Main PCB

TITLE: pi_low_cost_btle_scale

REV: 3

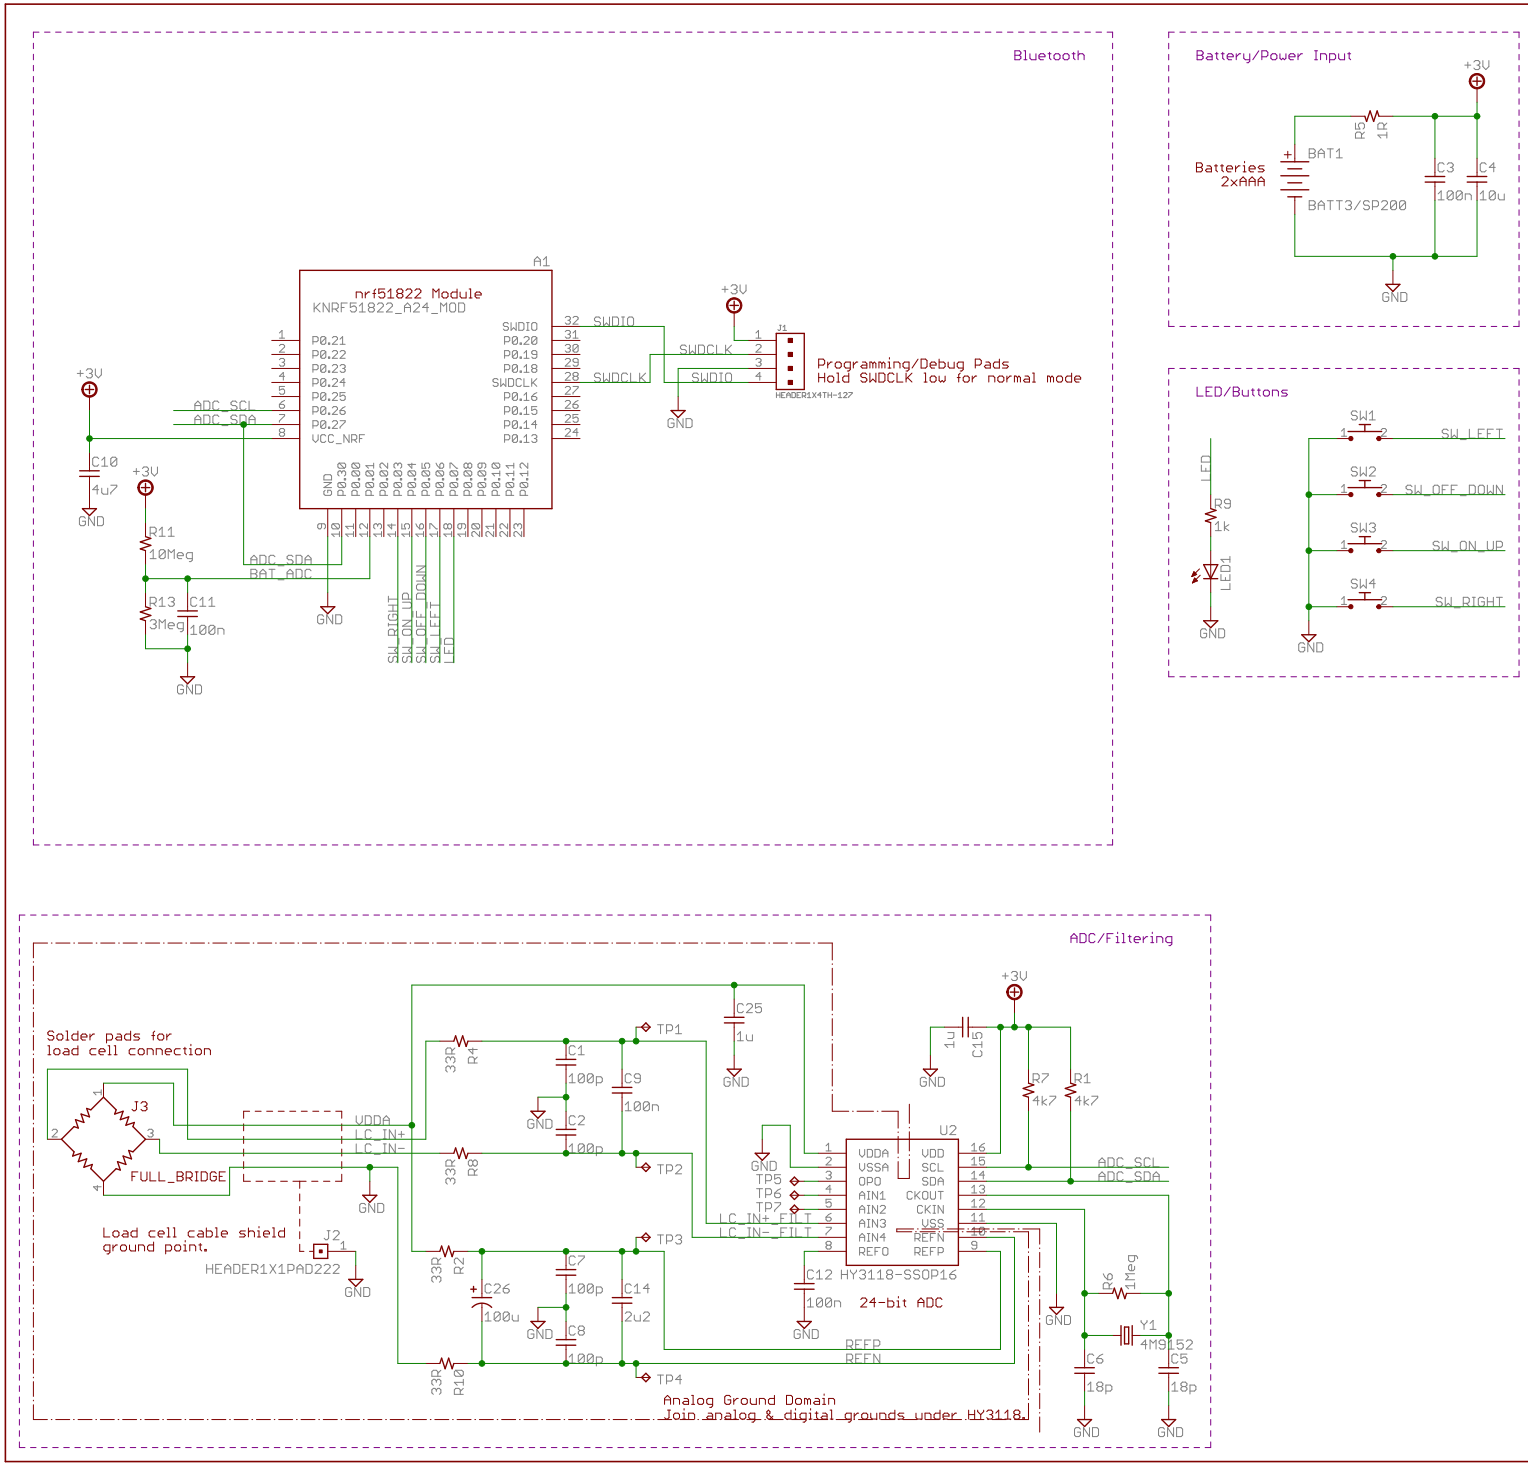
2: Fix R6 value, 270 --> 1Meg.
Replace nrf51822 and support components with module.

3: Switch to standard KNRF51822_A24 module.]
ADC_SCL on P0.26, ADC_SDA on P0.27
Delete SWDCLK pulldown R3 (included on module).
